**From:** Chou, Rich  
**Sent:** Thursday, January 07, 2010 11:53 AM  
**To:** Powell, Sid  
**Cc:** Franke, Mark; Lake, Louis; Sykes, Marvin; Morrissey, Thomas; Reyes, Rogerio  
**Subject:** FW: Wednesday NCRs  
**Attachments:** Spalling 3.pdf; Spalling 1.pdf

Please provide more details on NCRs 373986 and 373762. Thanks.

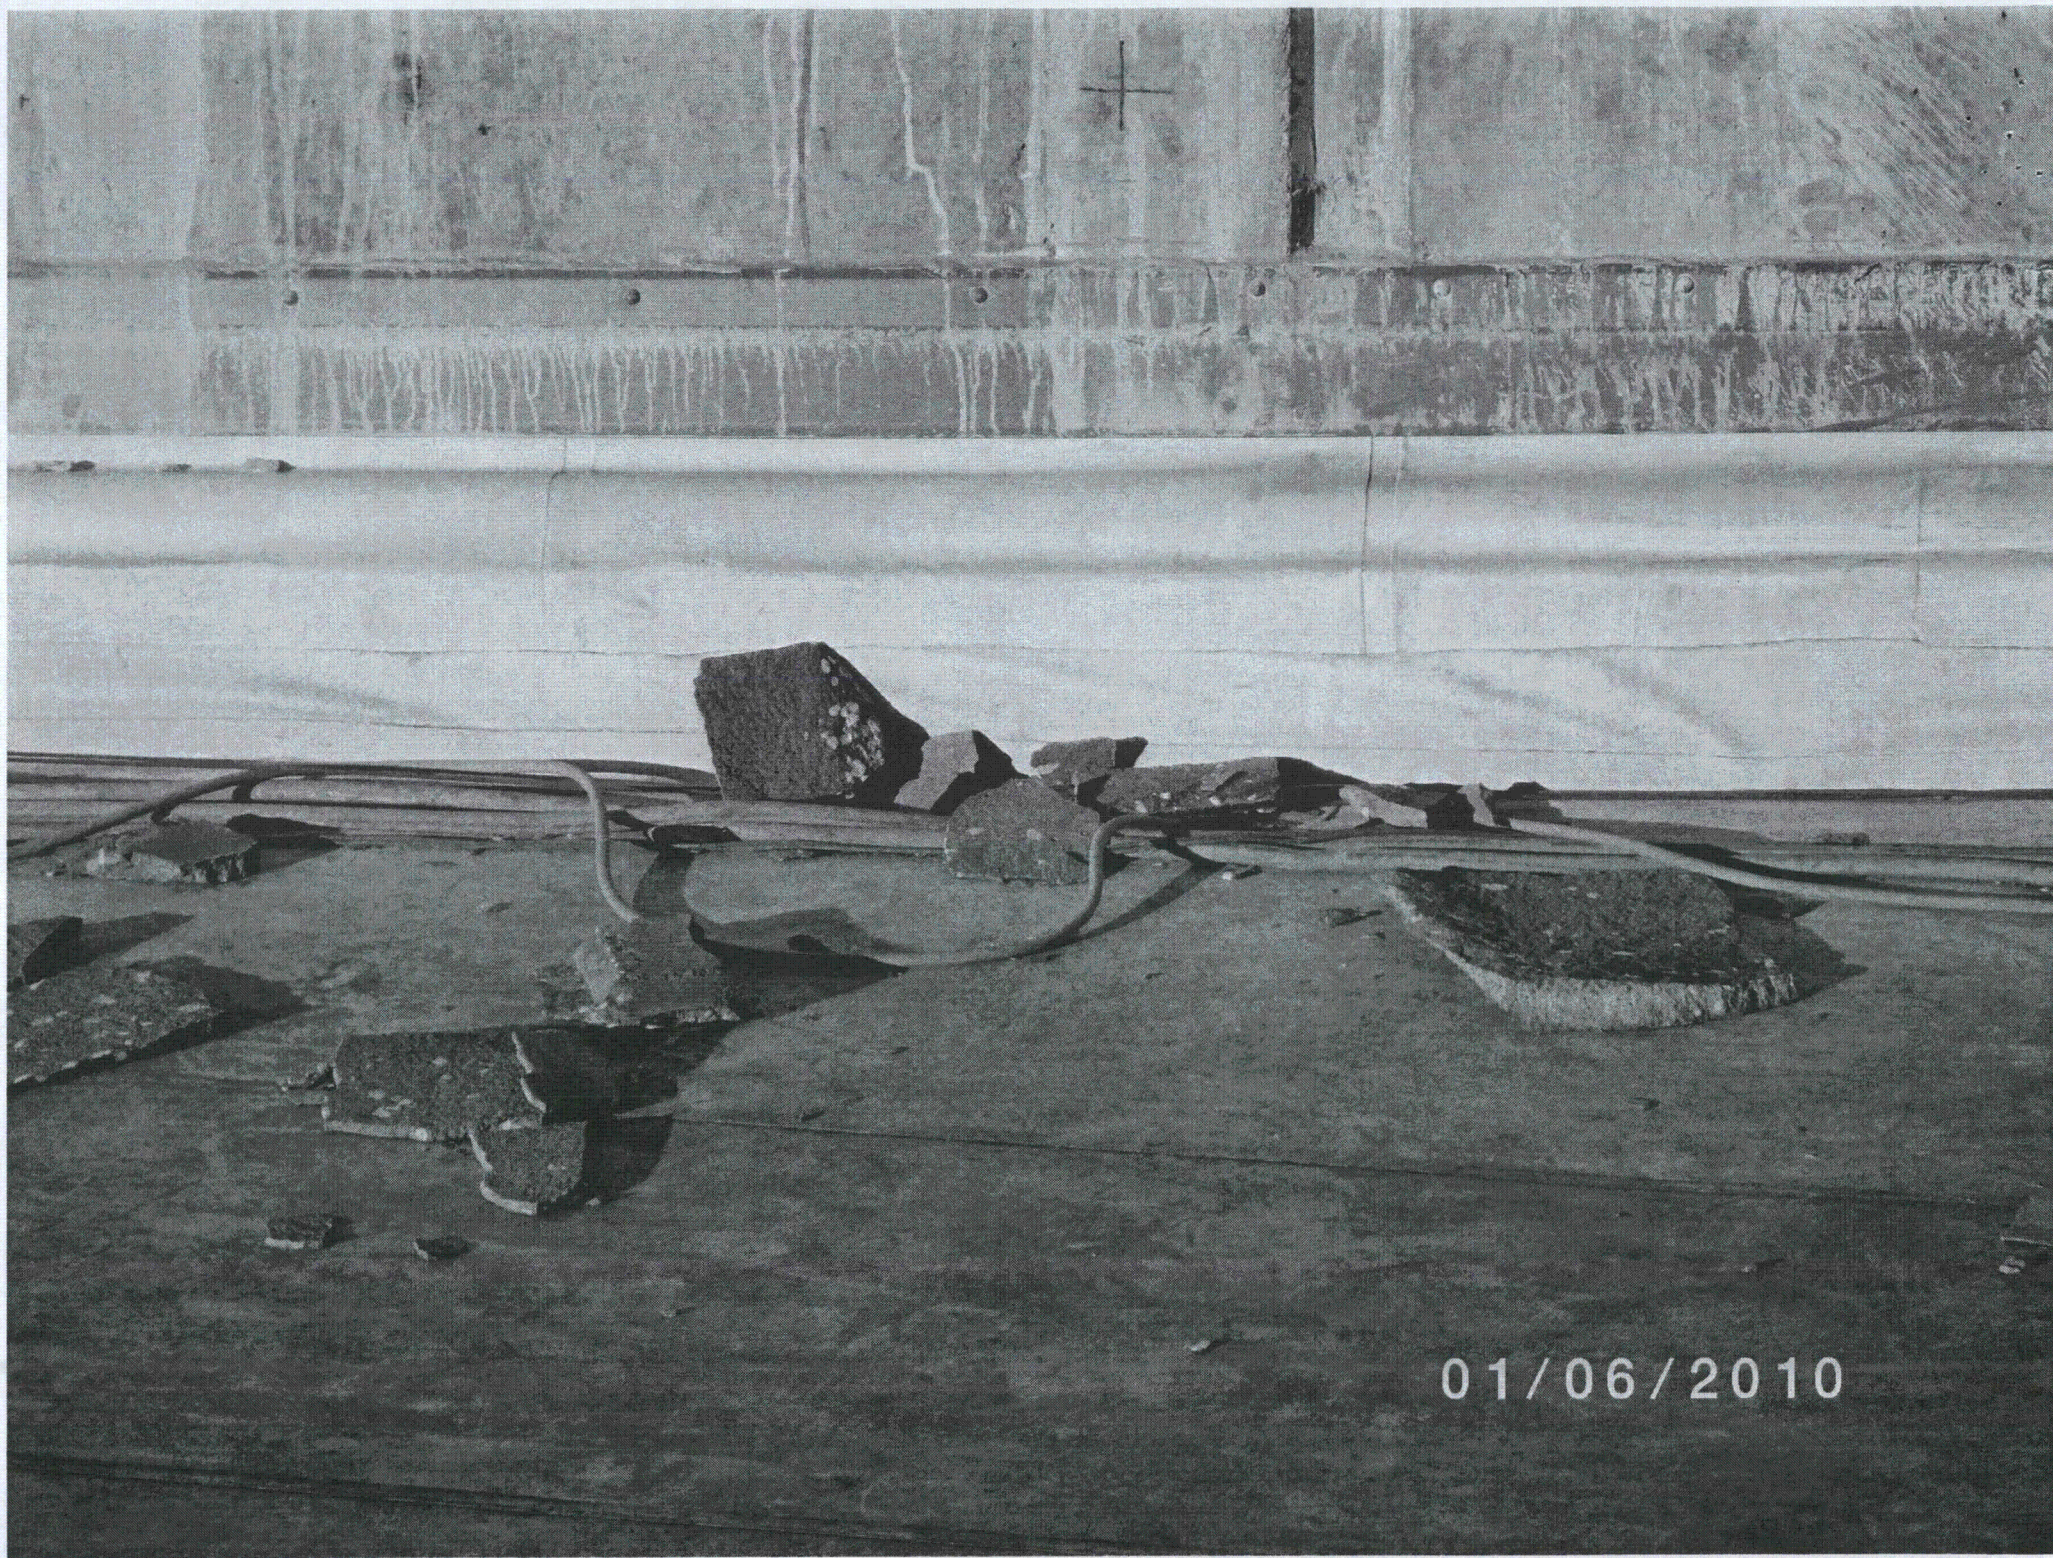
373762 – Attached are pictures of the area and the debris. It is too early to know why it occurred, but it may be related to the cold temperatures. There appears to be some moisture in the lower left corner.
